PLANNING COMMISSION STAFF REPORT
The Haworth Apartments
Conditional Use Permit and Design Review – CUP22-0016 / DR222-0011
Patrick R. and Elaine A. Maveety

FILE NO: CUP22-0016 and DR222-0011

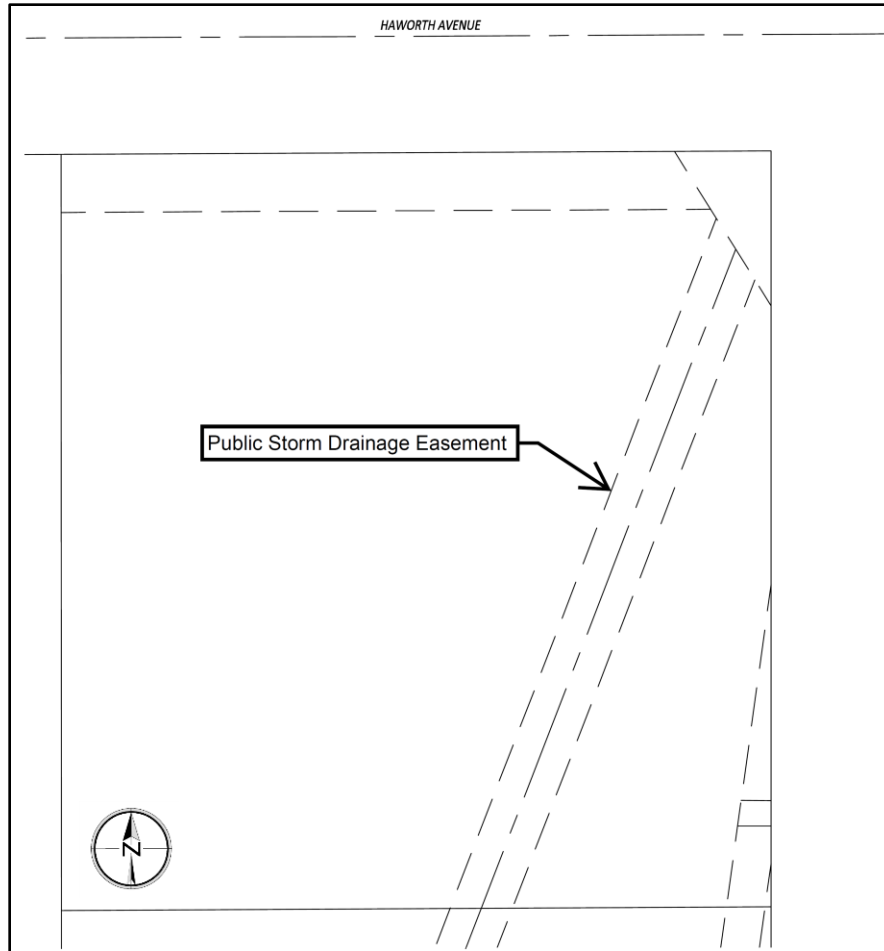
RESPONSE: The proposed development is subject to the design review process, and is therefore subject to the additional site and building design elements below.

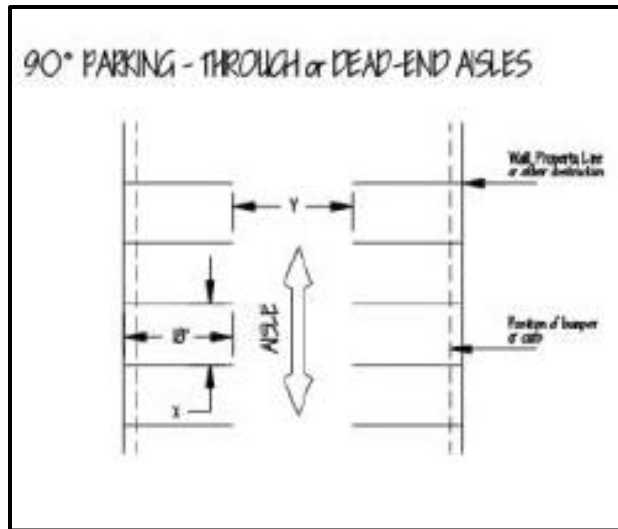
RESPONSE: The proposed development is not an affordable housing project; therefore, this section does not apply.

RESPONSE: No transit related facilities are proposed with this development; therefore, this section does not apply.

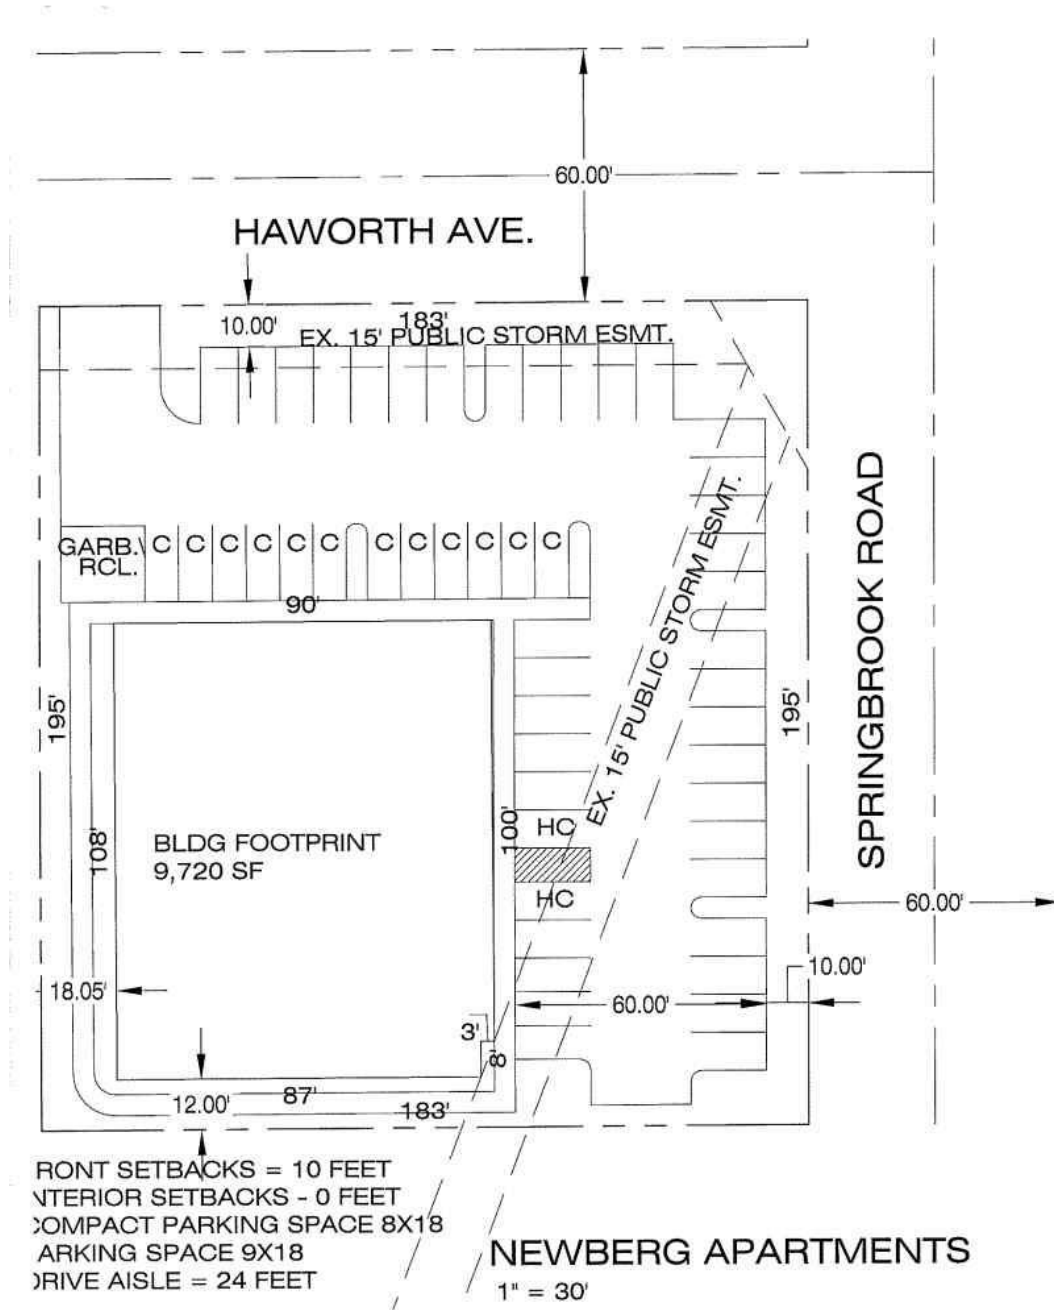
TUALATIN VALLEY FIRE & RESCUE COMMENTS:

BUILDING SAFETY DIVISION COMMENTS: Contact: Jared Bradbury:
Jared.Bradbury@newbergoregon.gov

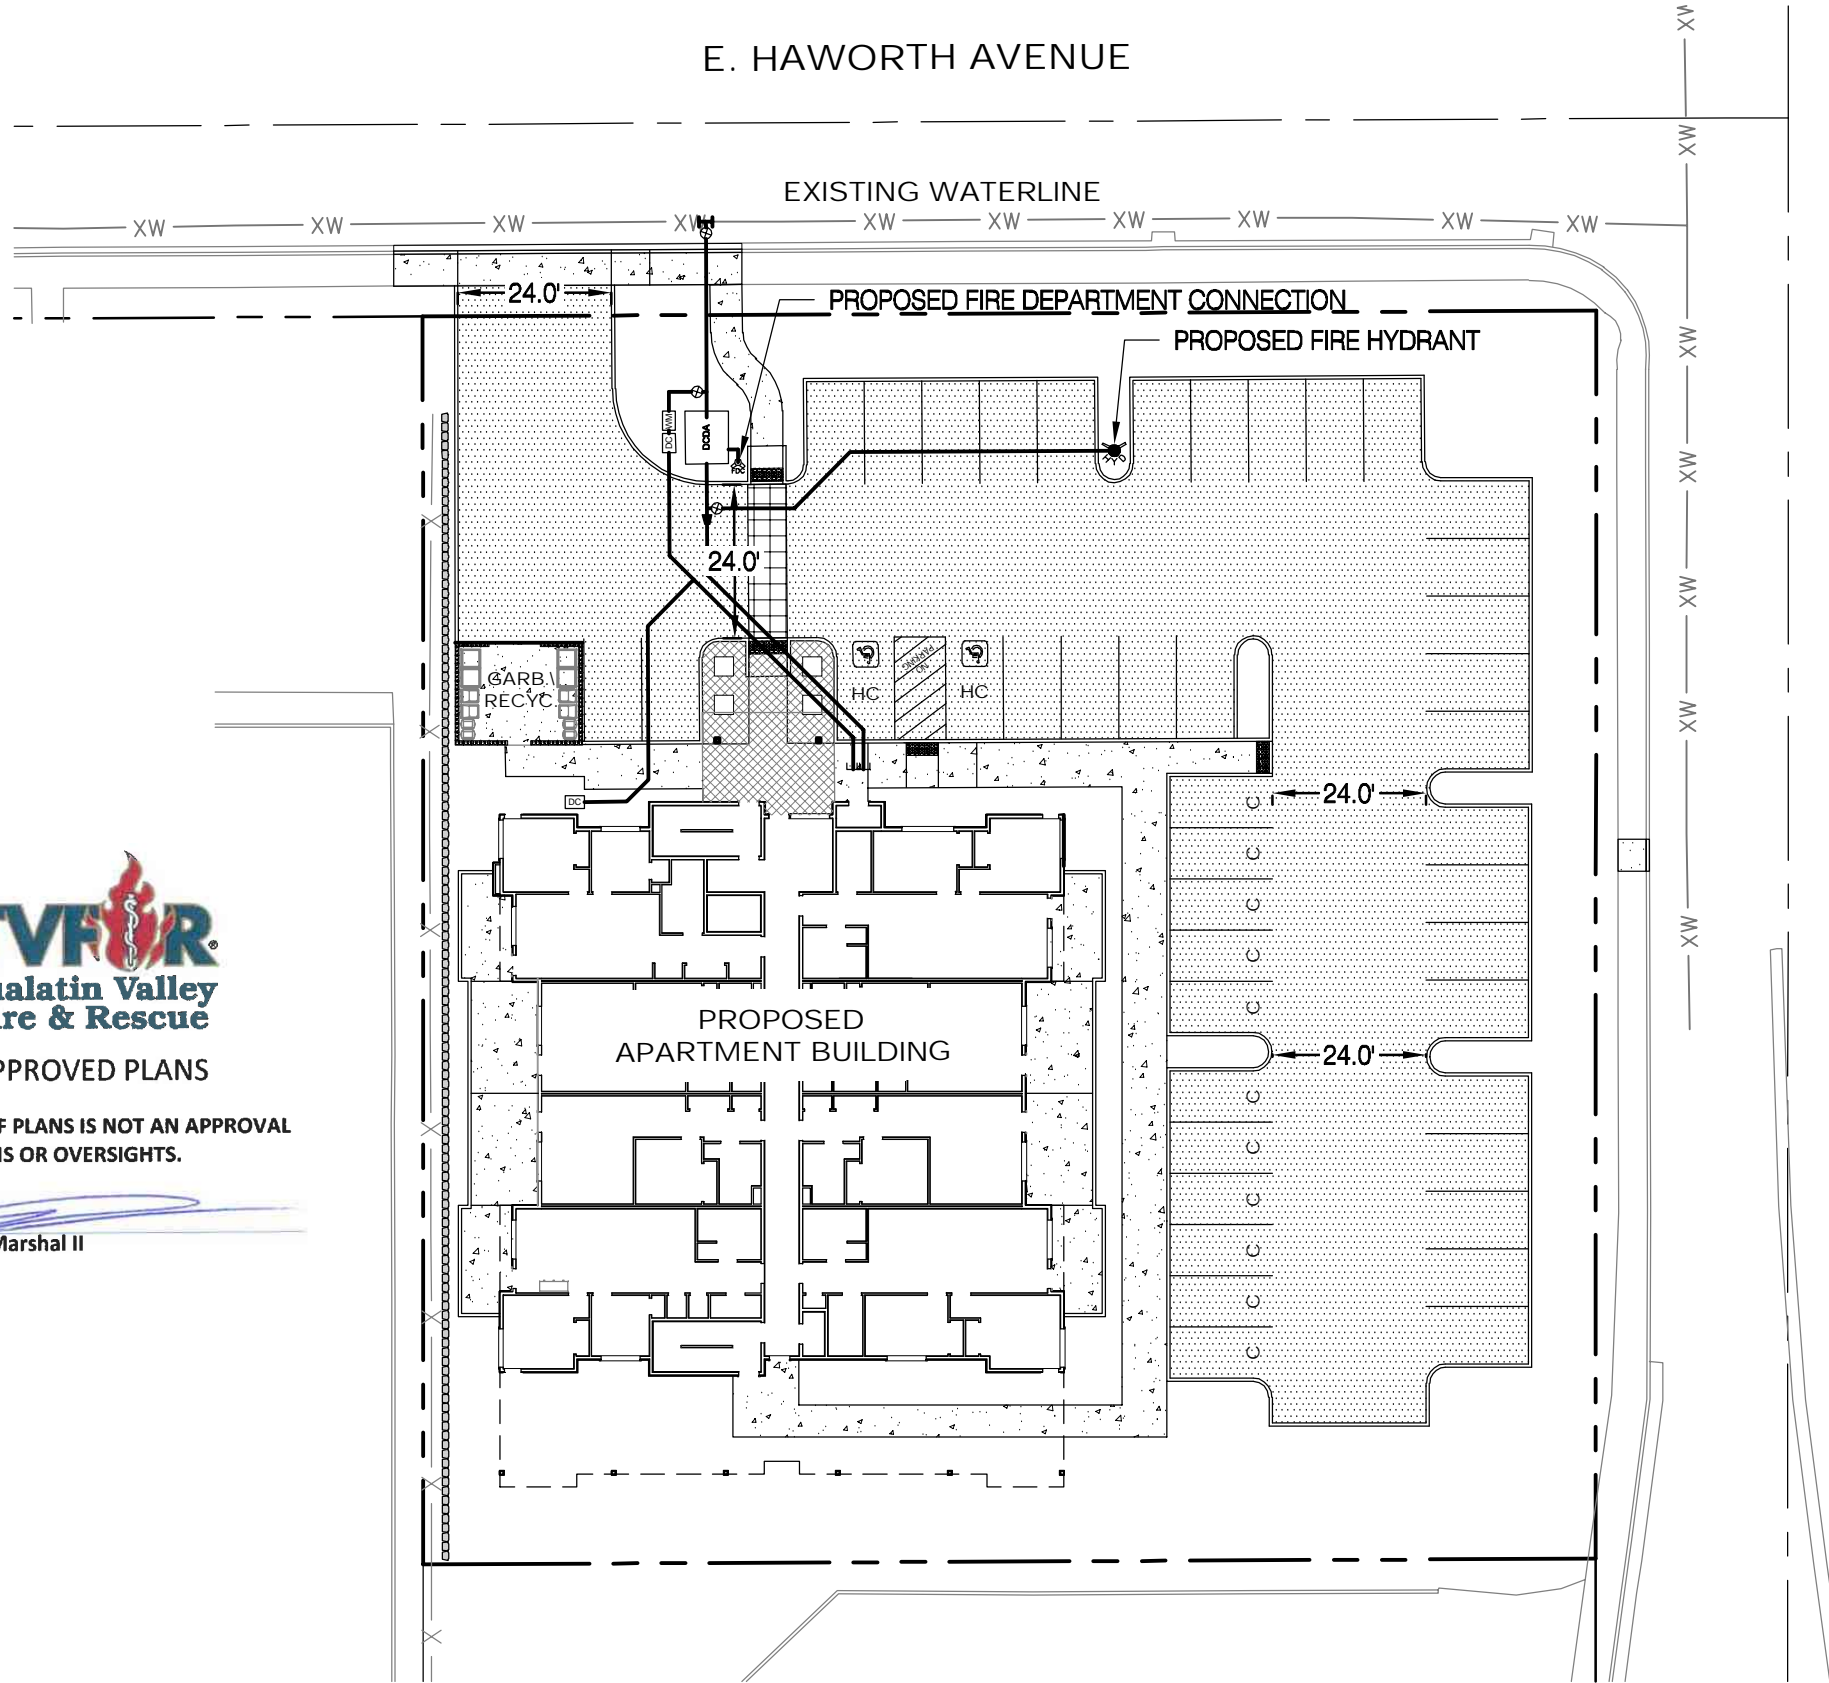
Inspection Comments:
